REVISED PROPOSAL FOR DRAFT AMENDMENT TO REGULATION No. 64 */
(Temporary use spare wheels/tyres)

Further Revision to ECE/TRANS/WP29/GRRF/2002/17/Rev.5

Transmitted by the expert from the United Kingdom

Paragraph 5.1.4.1., amend to read (the diagram is not amended):

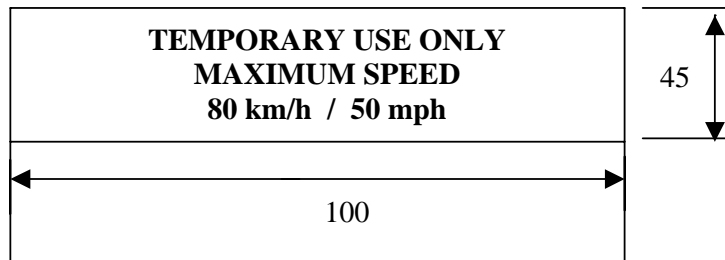
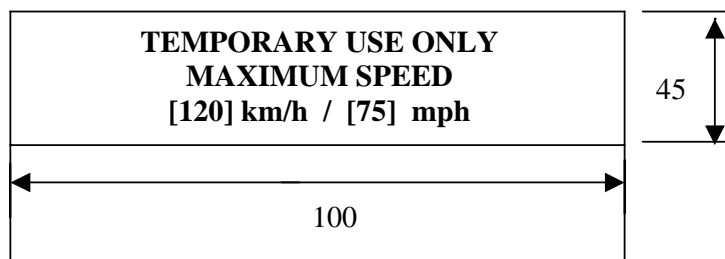
"5.1.4.1. An 80 km/h maximum speed warning symbol arranged in accordance with the diagram below shall be permanently displayed on the outer face of the wheel in a prominent position.

In the case of vehicles intended to be sold in countries using imperial units of measurement, an additional warning symbol, identical to that described above, with the exception that the figure "80" shall be replaced by "50" and the wording "km/h" by "mph", shall be permanently displayed on the outer face of the wheel in a prominent position.

Alternatively a single warning symbol arranged in accordance with the diagram below, shall be permanently displayed on the outer face of the wheel in a prominent position.

Upper case letters shall be at least 5 mm high and the numbers "80" and "50" shall be at least 20 mm high with the elements that make up each character of the number at least 3 mm line thickness. Lower case text shall at least have a line height of 5 mm. All text shall be enclosed in a border and be on a background of contrasting colour.

The requirements of this paragraph shall only apply to types 1, 2 and 3 temporary use spare unit as defined in paragraphs 2.4.10.1., 2.4.10.2. and 2.4.10.3."
